SERVICE BULLETIN

REPLACEMENT OF THE PROPELLER GEARBOX

SB-912-056 UL

SB-914-038 UL

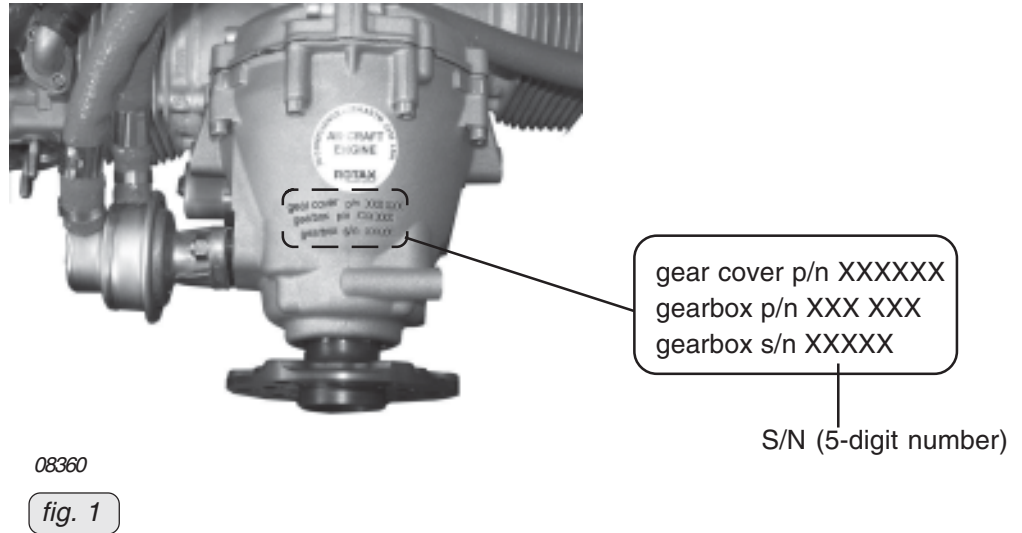
- ◆ NOTE: The respective serial number of the propeller gearbox is visible on the gearbox housing (see fig. 1)

- ◆ **NOTE:** The relevant serial number of the gearbox is visible on the gearbox housing (see fig.1).
